#### Service Provider Letter

| C | WS File Number |
|   | 24-000272      |

| Jurisdiction:  | City of Beaverton  | Review Type:  | No Impact                                       |  |
|--|--|---|---|--|
| 1S127CB001   | Tax lot ID   |   | evelopment Activity Elementary School Portables |  |

EX. B

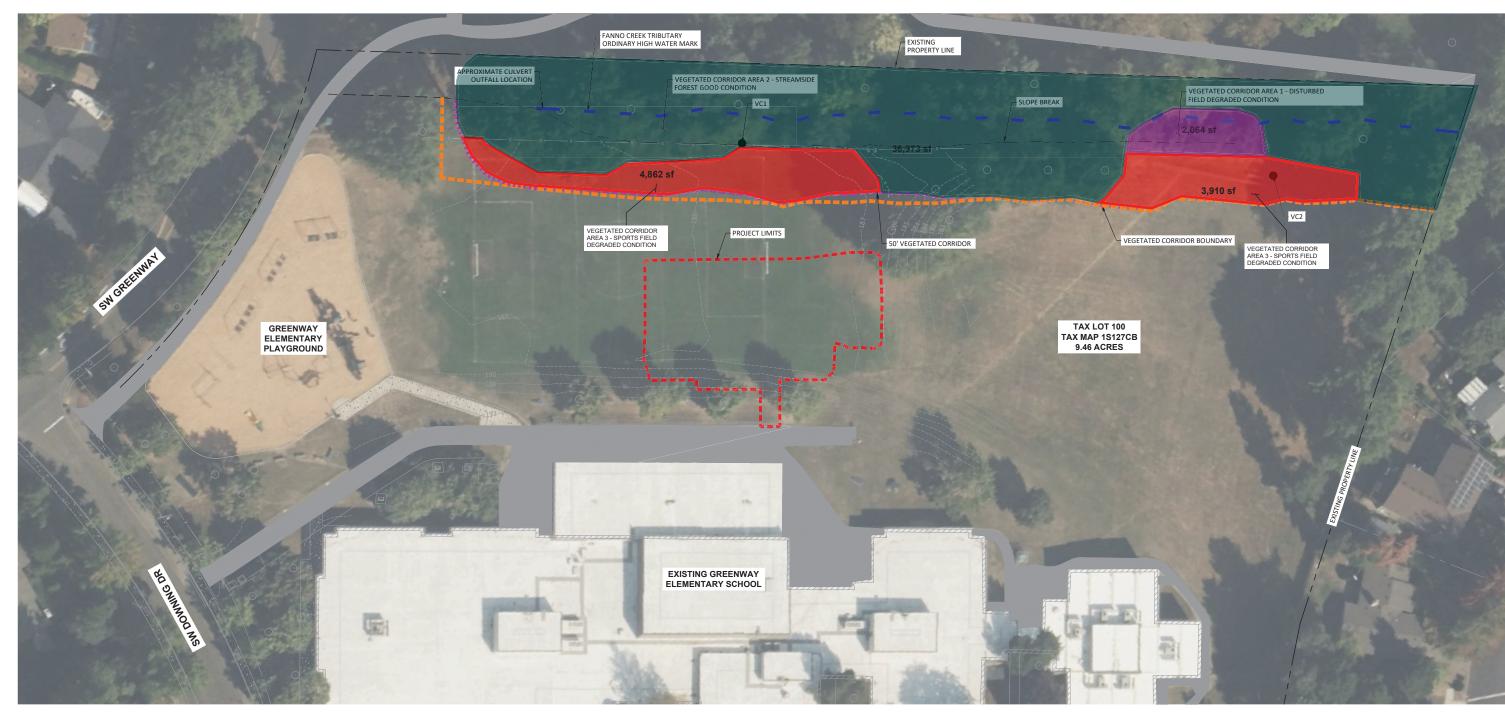
24-000272 Approved Clean Water Services FOR ENVIRONMENTAL REVIEW Date 05/21/2024 SPL ATTACHMENT 1 OF 2

EX. A

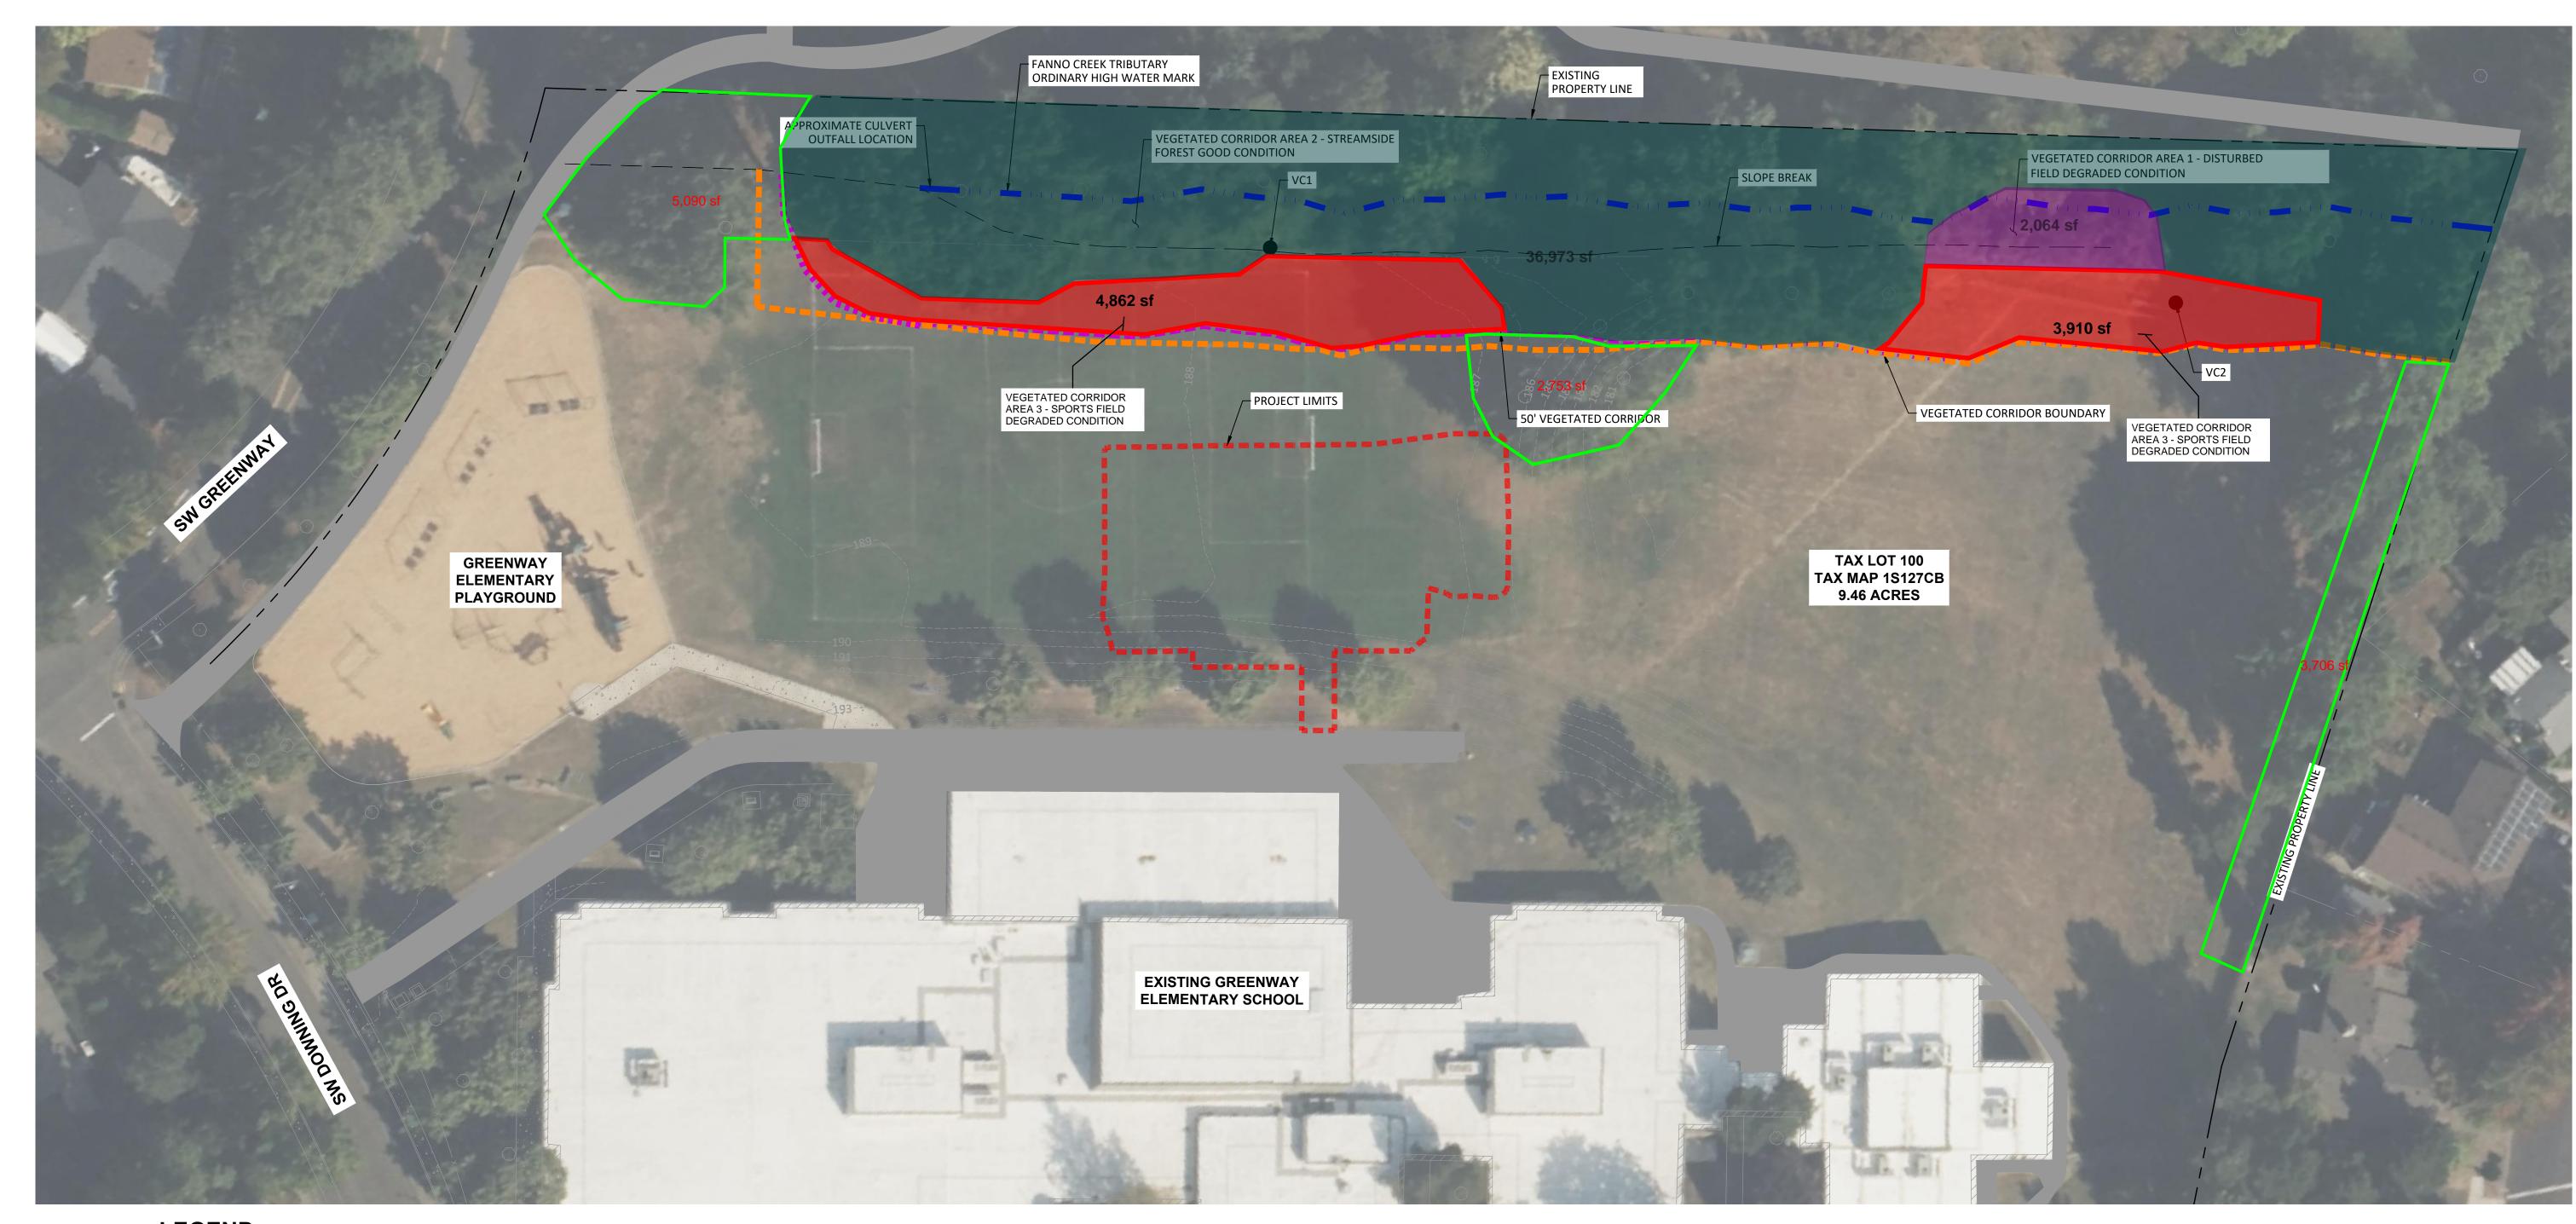
CWS FILE NO. 24-000272 Approved Clean Water Services FOR ENVIRONMENTAL REVIEW Date 05/21/2024 SPL ATTACHMENT 2

Area 1-- 2,063 SF Plant to Good Condition

Area 2 -- 36,973 SF

Remove invasive species and plant bare areas >25 SF

Area 3 -- 8,772 SF

Retain sports field use. Provide equivalent area contiguous with Vegetated Corridor and plant to Good Condition, if Degraded or Marginal, or remove invasive species and plant bare areas >25 SF if Good.
